AGENDA

Architectural Review Board

November 19, 2014

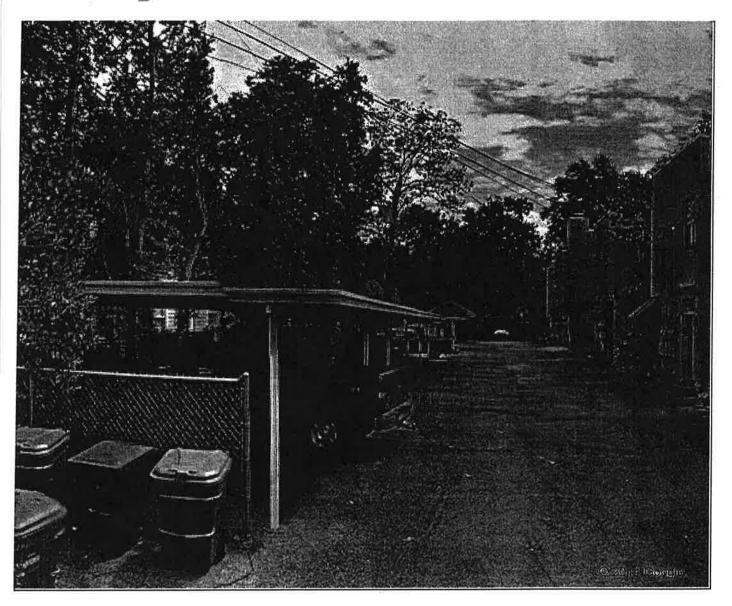
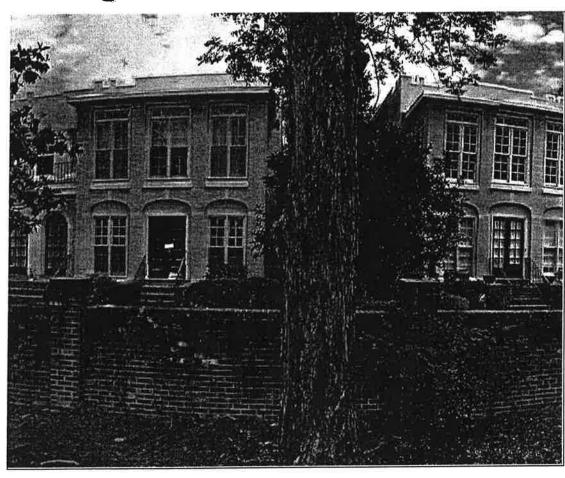
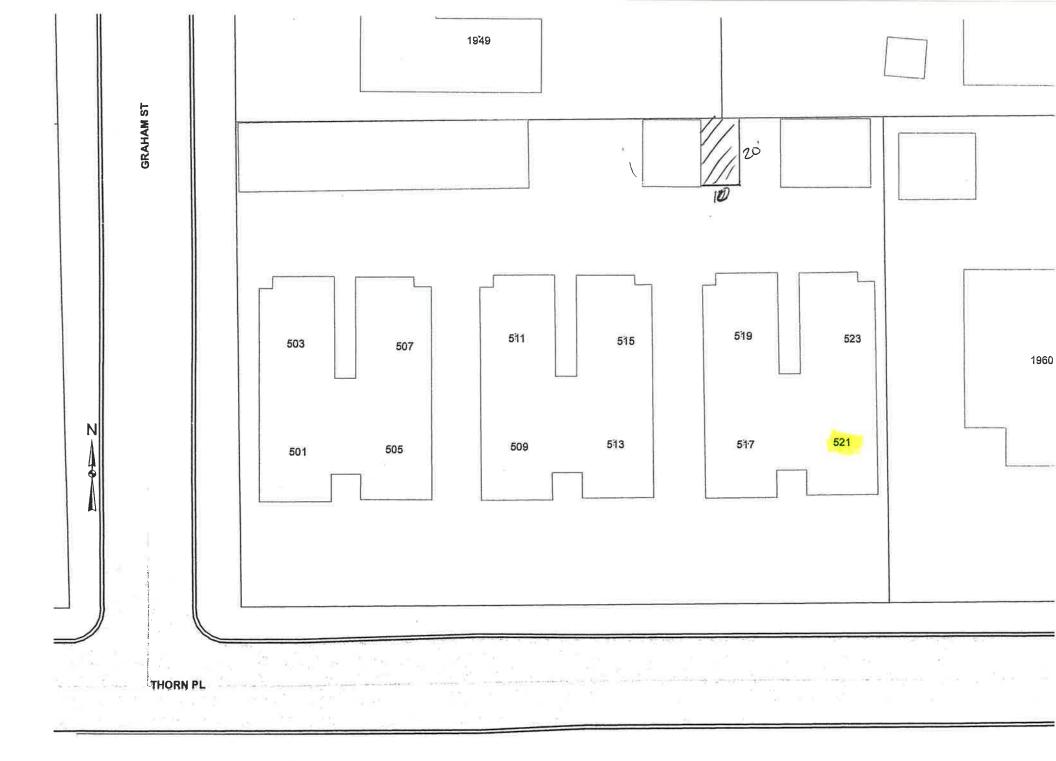
• The proposed addition is consistent with the existing carport structures that were grandfathered into the district. While the Board has not generally approved car ports in this material or configuration when newly proposed, a different style in this location would stand out.

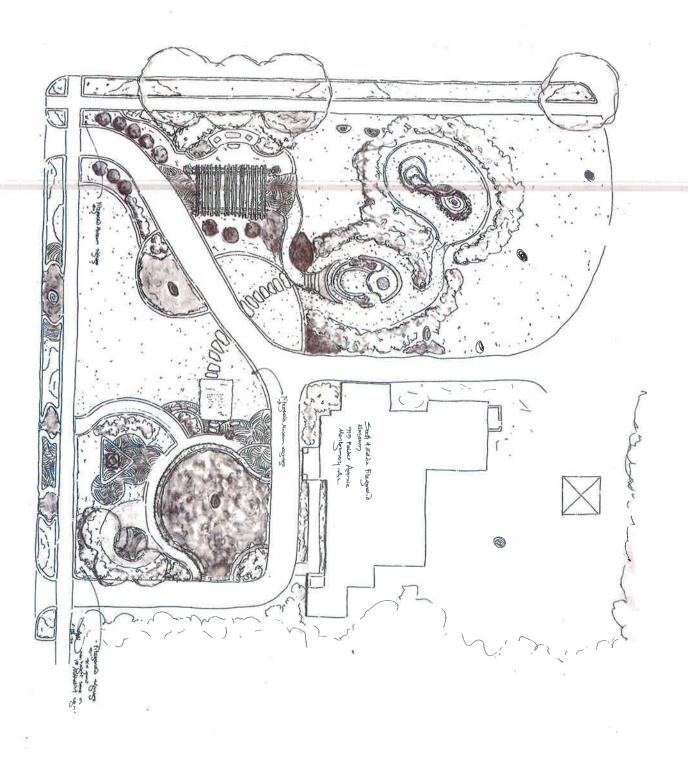
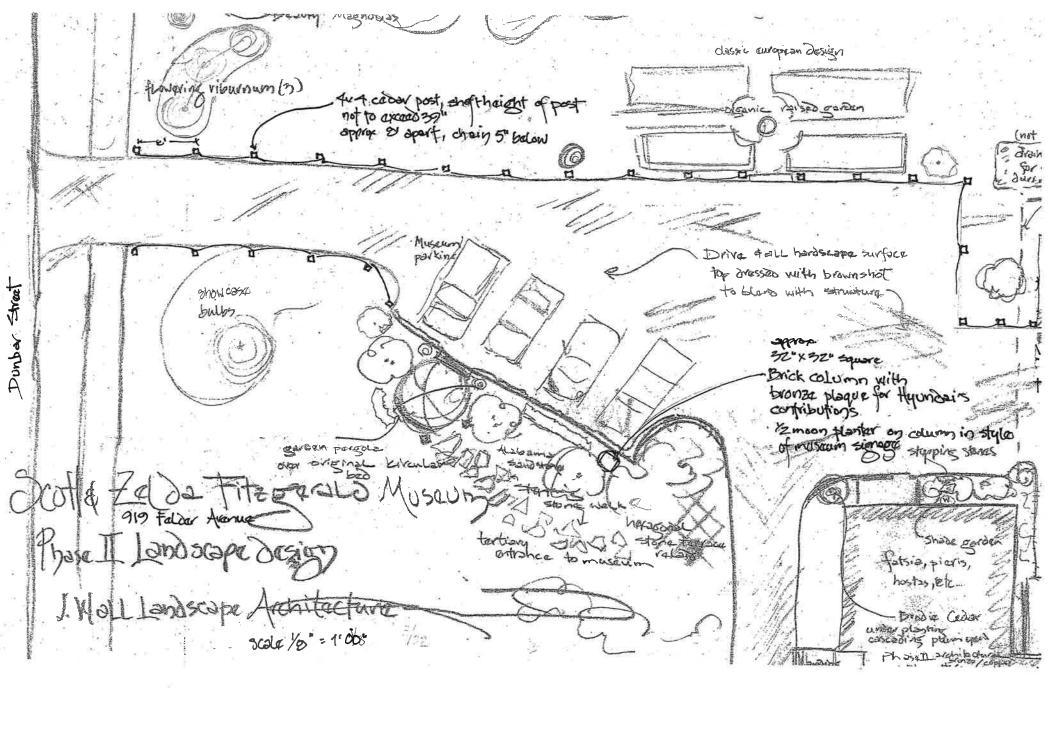
• The guidelines don't speak to defining parking areas. The Board needs to determine if the cedar posts and chains at the proposed height are appropriate for a building within a residential setting, regardless of use.

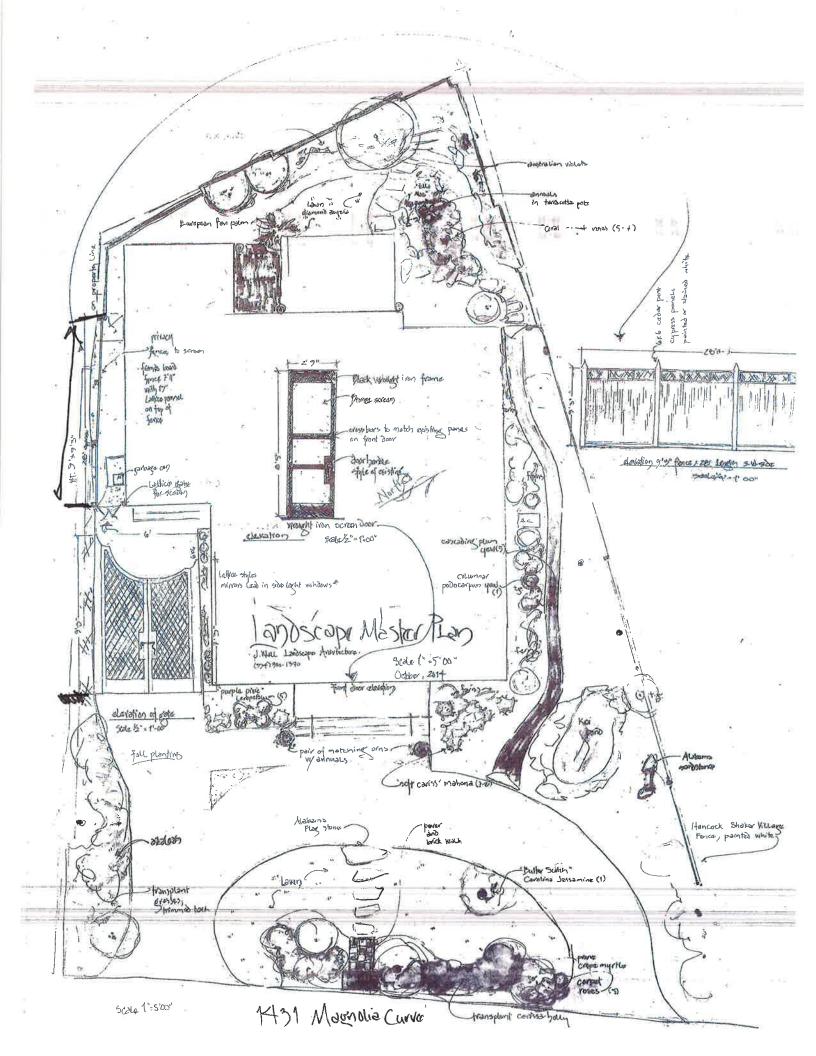
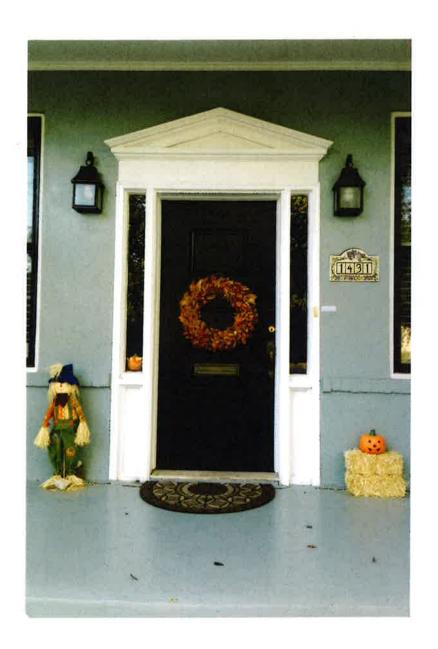
- The standard fence height in the guidelines is 6'. The Board has on occasion approved fences that were taller (7'-8') in locations where the grade change warranted a taller fence. The Board needs to determine if 9' is appropriate in the proposed location.
- A variance is required for any fence over 7' in height.

DEERRY STREET RESIDENCE

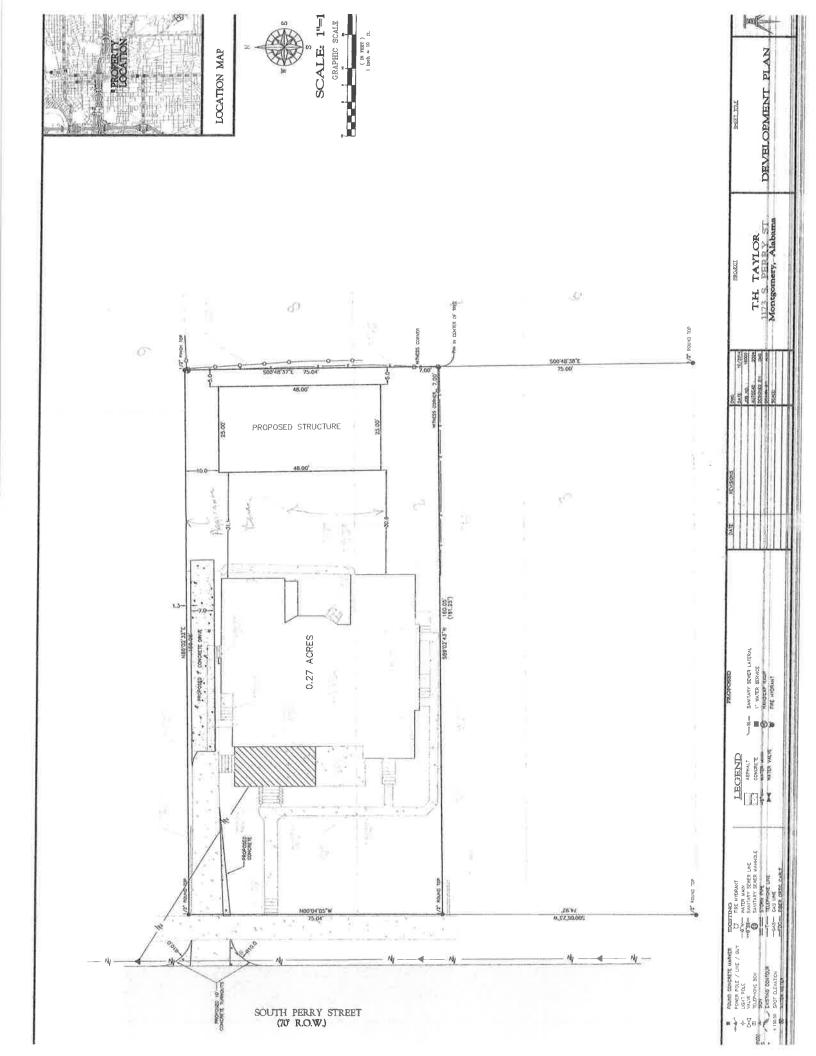
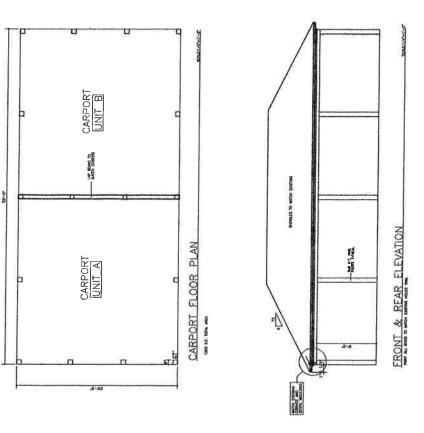
- The building is being converted from a multi-unit building to a duplex, the parking structure will provide two covered spaces for each unit.
- There is a similarly sized parking structure behind the property just south of this property.

3310 Lebron Road Planned Improvements

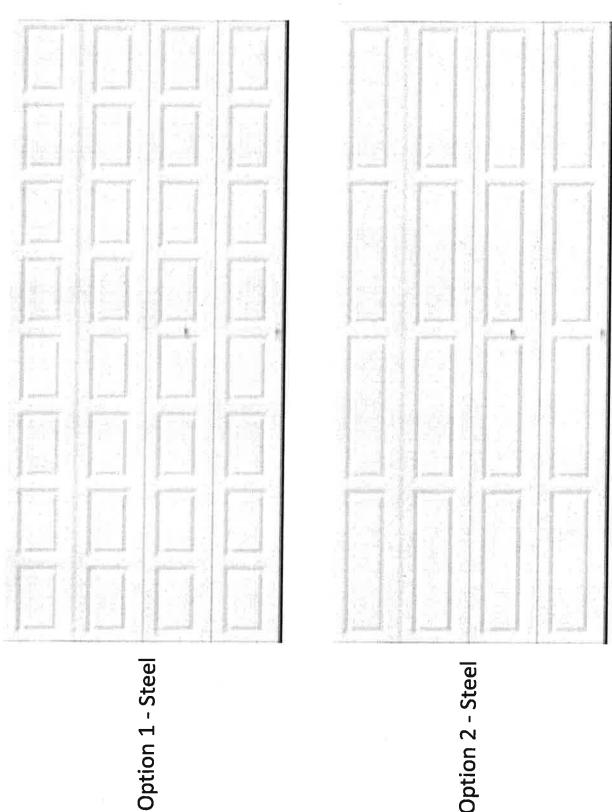
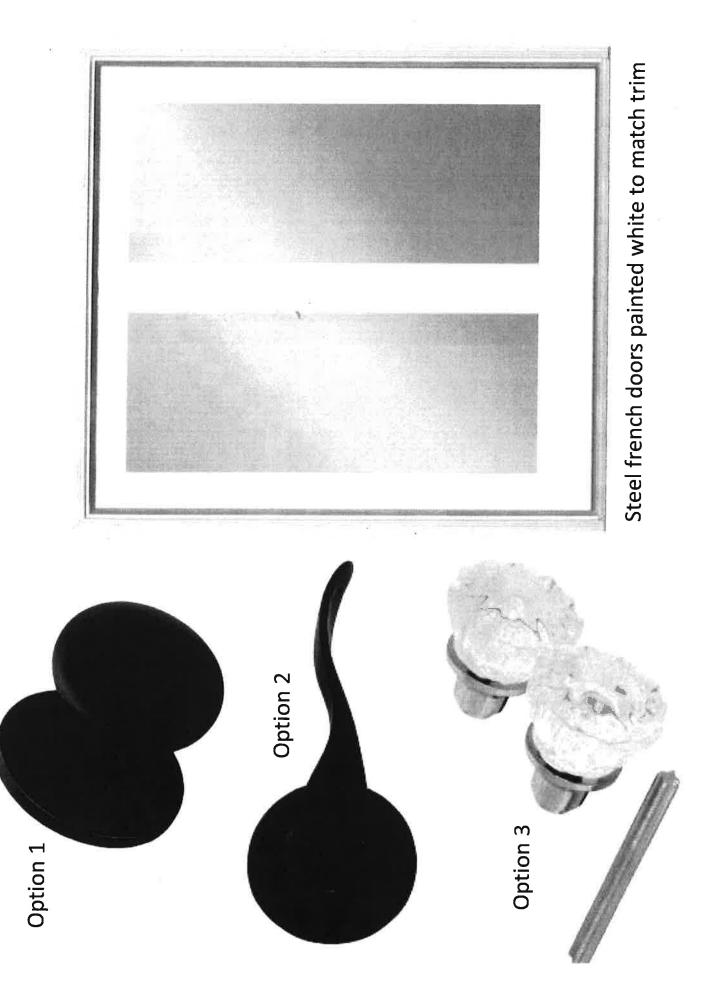
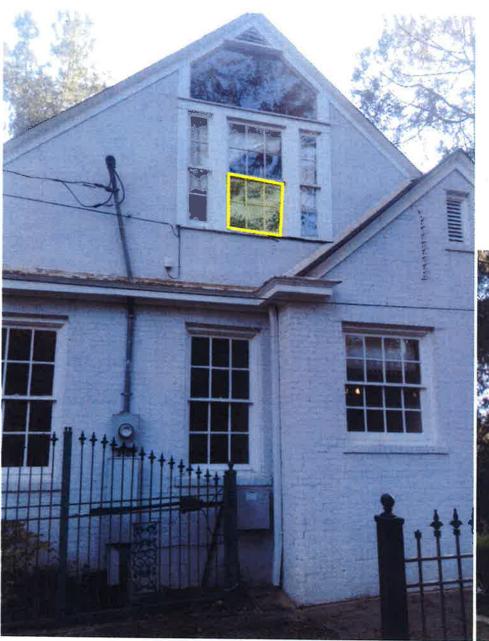
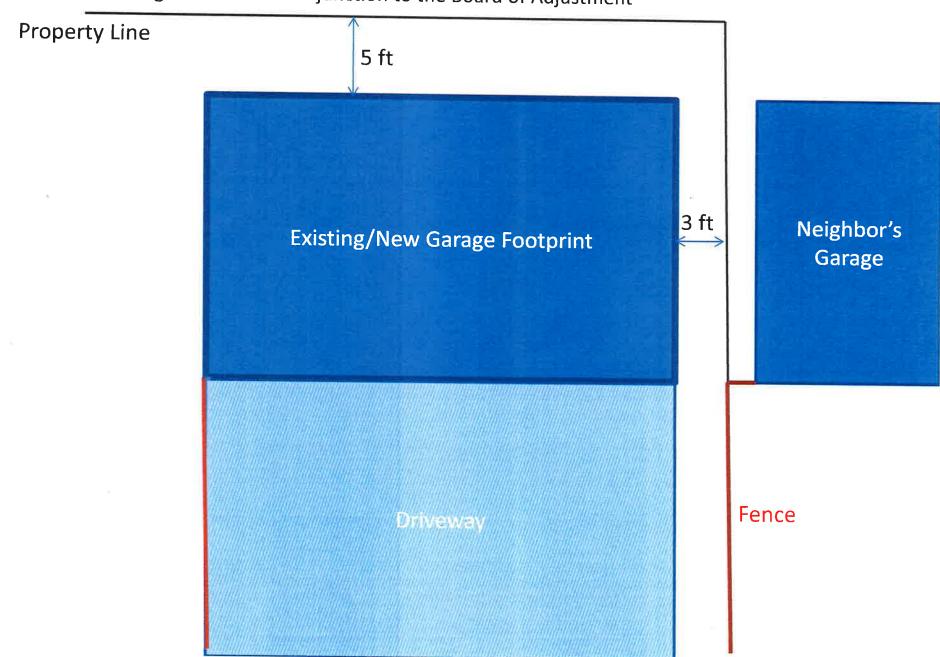
- The Board has approved the use of Hardie siding on outbuildings in the past.
- Driveway can be repoured in the same footprint without ARB approval.
- If the attic windows are milled to match (the owner was meeting with Marshall Lumber), ARB approval would not be required. Any other window would need to be wood or aluminum clad wood, simulated or true divided lite, with a matching pane configuration.
- No replacement is proposed for the tree. Tree is healthy, but is in the way of the proposed patio. If approved, Urban Forester recommends a replacement tree be required.

AN ADDITION TO TO THE RESIDENCE OF MR. AND MRS. WILLIAM R. WIBLE

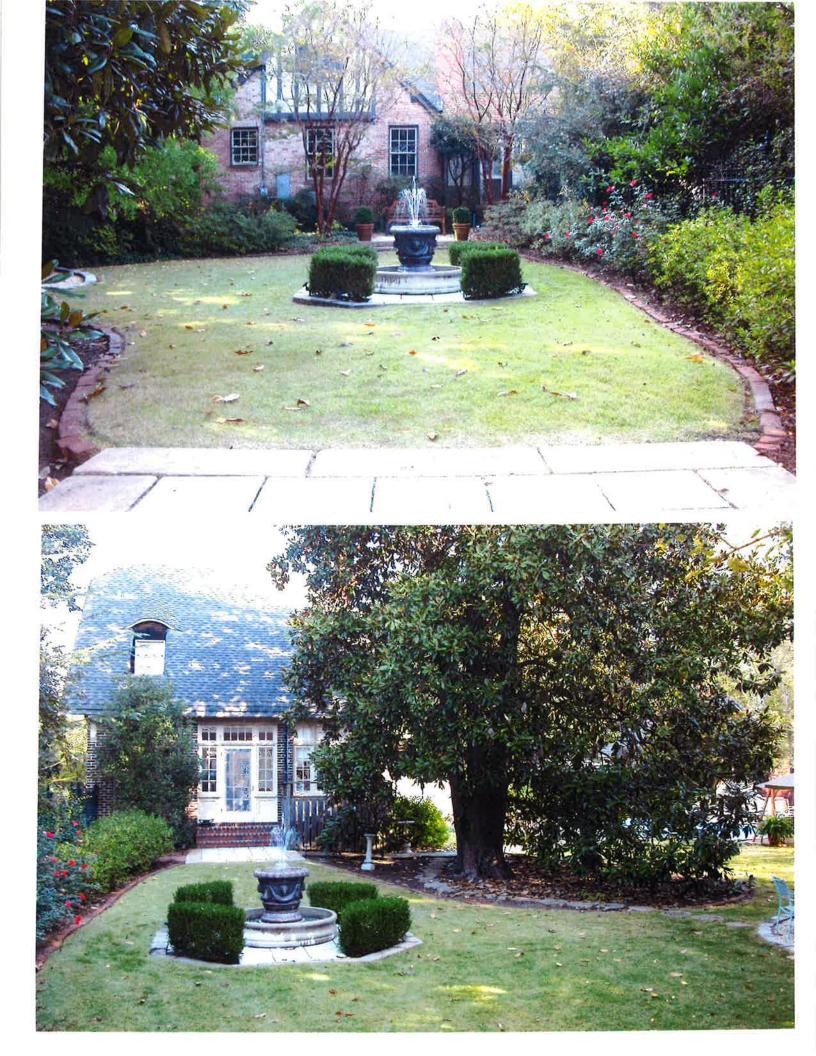
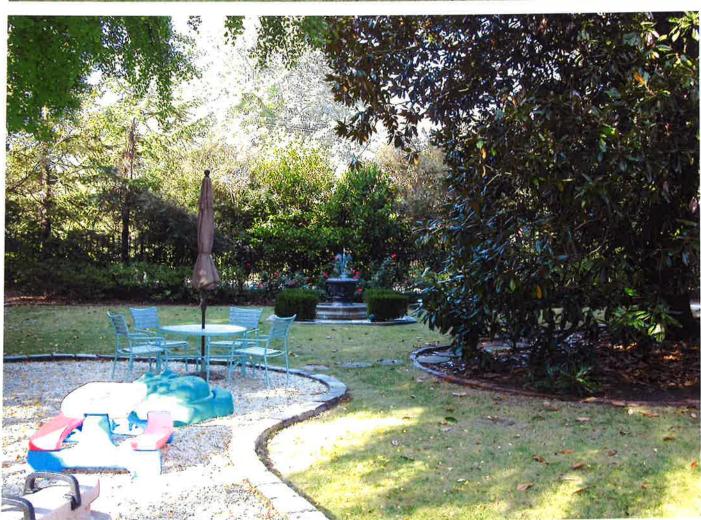
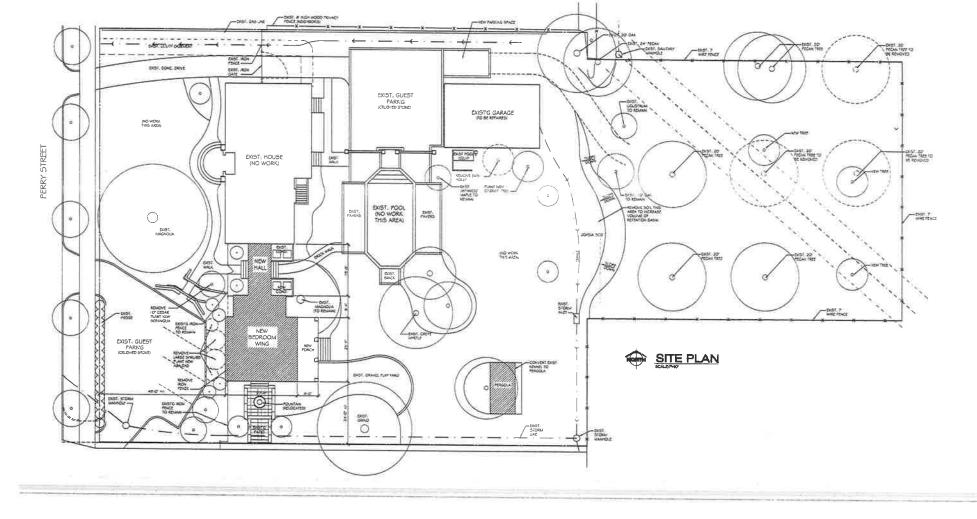
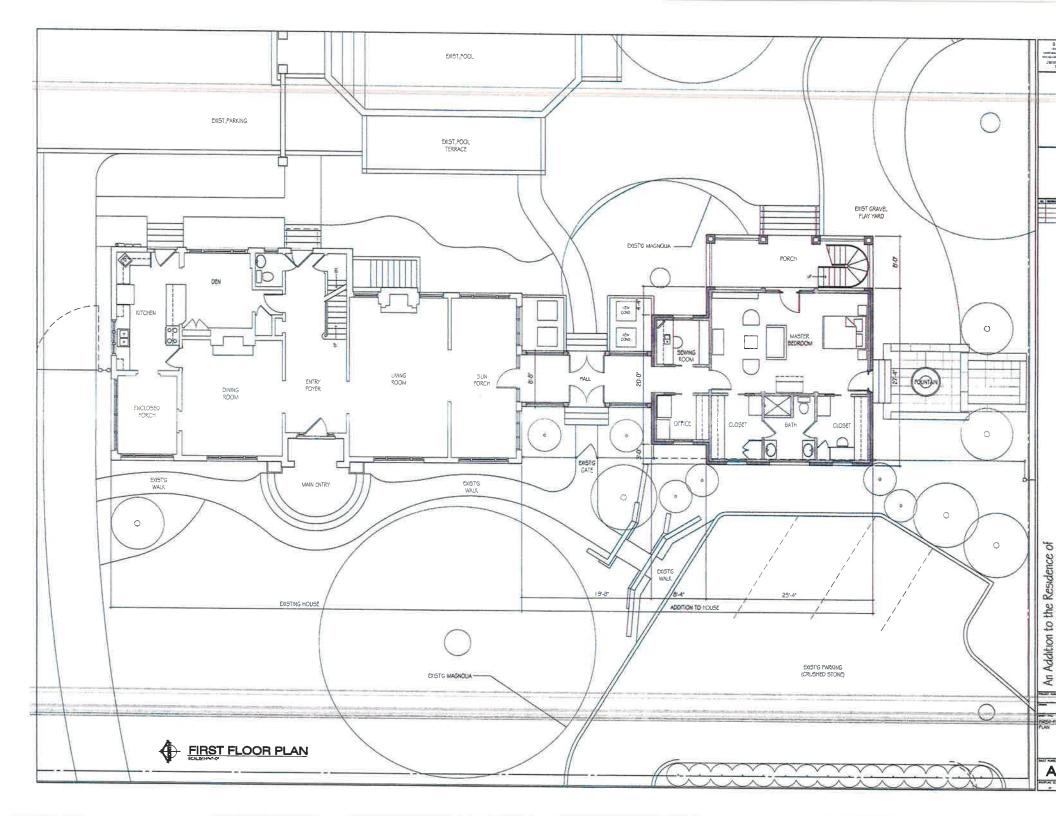
•	No objections ((on construction of	r tree removal	ls and	proposed	replacemen	t)
---	-----------------	---------------------	----------------	--------	----------	------------	----
